Class II Permissive Change Request Letter

Date: August 14, 2024
Subject: Requesting Class II permissive change for FCC ID: 2AVMJX6

The purpose of this letter is to request a Class II Permissive change for FCC ID: 2AVMJX6, original granted on 10/18/2022.

Applicant: XPLORA Technologies AS

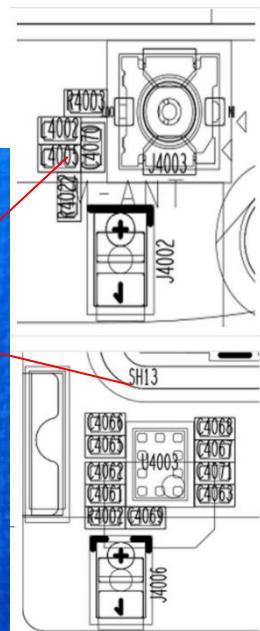
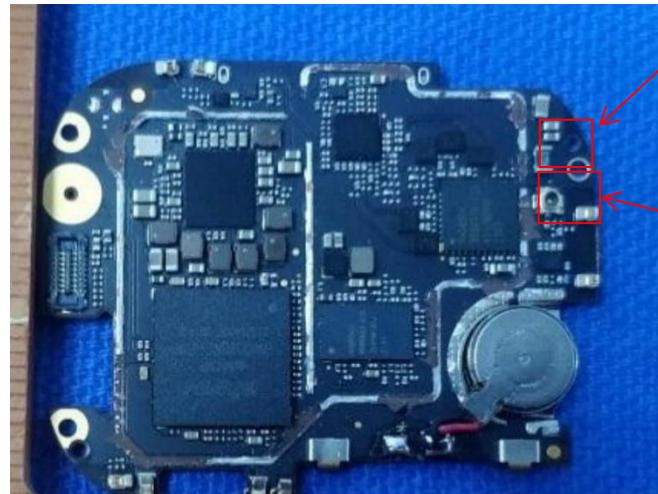
The main change filed (2G/3G/4G Antenna Port) is:

1. Changed manufacturer for the capacitor (C4071, C4062);
2. Changed manufacturer for the capacitor (R4002, R4003);
3. Removed the inductor(L4005);

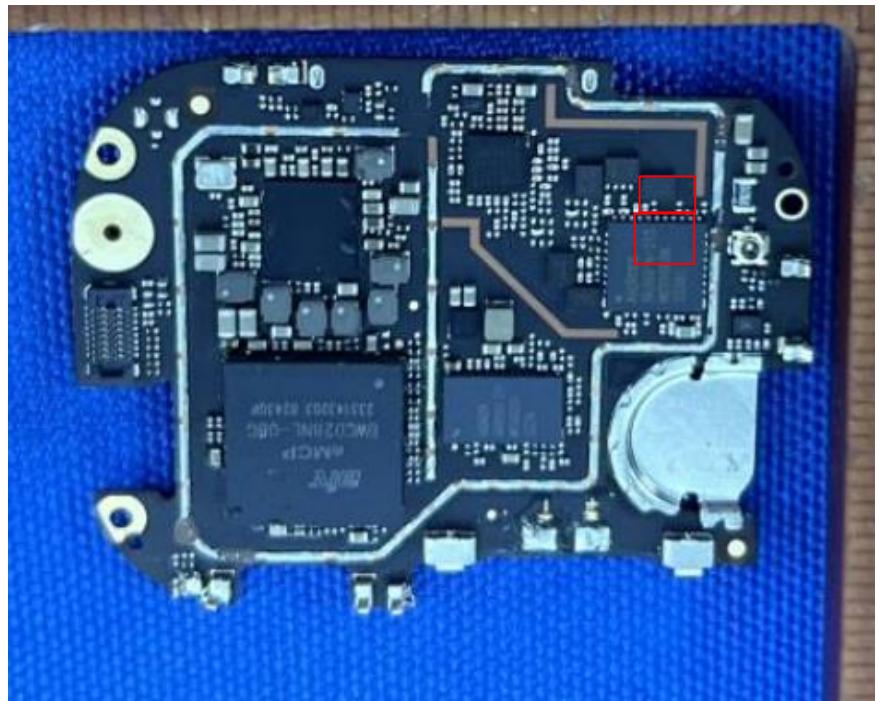
Placement	Model	Parameter	Supplier	Remark	
C4071	0 Ω	RC0201JR-070RL 0201WMJ0000TEE	RES-DISCRETE, 0201, 0ohm, +/-5%, 1/20W RES-DISCRETE, 0201, 0ohm, +/-5%, 1/20W	Yageo uniohm	new supplier
	15NH	SDCL0603Q15NJT02B01 SDCL0603Q15NJT02B03	IND_RF, 0201, 15nH, 0.85ohm, 0.16A, +/-5% IND_RF, 0201, 15nH, 0.7ohm, 0.25A, +/-3%	Sunlord	
C4062	22PF	V220J0201C0G500NAT C0201C0G220J500NTA	CAP-CERAMIC, 0201, COG, 50V, 22pF, +/-5% CAP-CERAMIC, 0201, COG, 50V, 22pF, +/-5%	微容 宇阳	new supplier
	0 Ω	RC0201JR-070RL 0201WMJ0000TEE	RES-DISCRETE, 0201, 0ohm, +/-5%, 1/20W RES-DISCRETE, 0201, 0ohm, +/-5%, 1/20W	Yageo uniohm	
L4005	removed

Original

New

I attest that such change will not affect LTE Radio section from antenna port (after pre-check, conducted power no higher than original) and WLAN/BT section (including antenna port, radiated emission, SAR), only effect LTE Radiated spurious emission, ERP/EIRP and LTE SAR section.
